# SERVICE BULLETIN

EL16-017a
 NTB16-039a
 May 31, 2016

## 2015 PATHFINDER WITH 4WD; LOW POWER / STOP LAMPS STAY ON

APPLIED VEHICLE: 2015 Pathfinder (R52) 4WD with V6 engines only

Figure 1

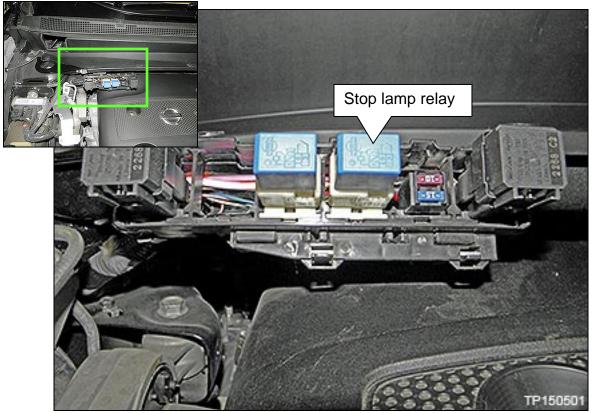
- 1. Remove the stop lamp fuse (#10) from the "junction box" fuse block in the Instrument panel.
- 2. Remove "fuse and relay box" (fuse box) cover and locate stop lamp relay (Figure 1).
  - Fuse box located on bulkhead (engine wall) above engine.

Figure 3

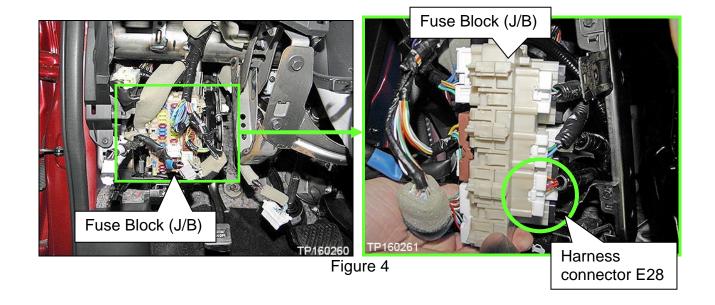
- 1. Remove instrument lower panel LH
  - Refer to the Electronic Service Manual (ESM), section IP – Instrument Panel for removal information.

Figure 5

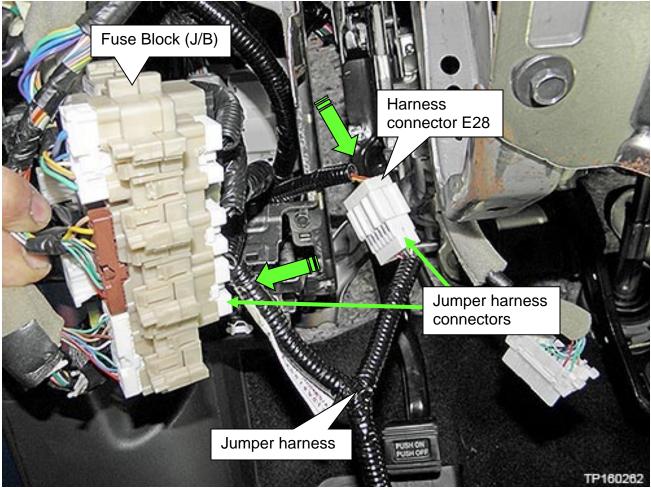
3. Connect jumper harness (part #: 24167-9PB1E) between Fuse Block (J/B) and harness connector E28 (Figure 5).

Figure 10

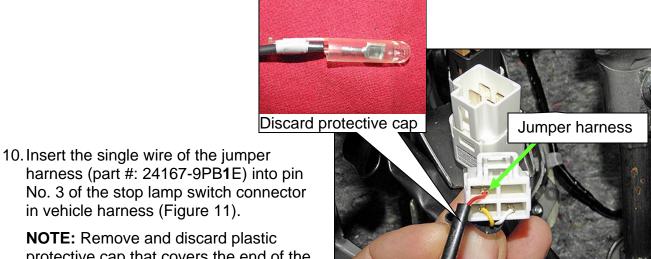
9. Locate the stop lamp switch connector and disconnect it from stop lamp switch.

Figure 15

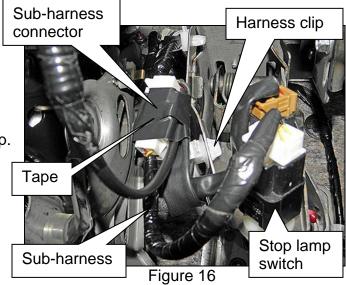
- 13. Connect the sub-harness to the stop lamp switch (Figure 15).
- 14. Unclip the stop lamp harness from the support bracket (Figure 16).
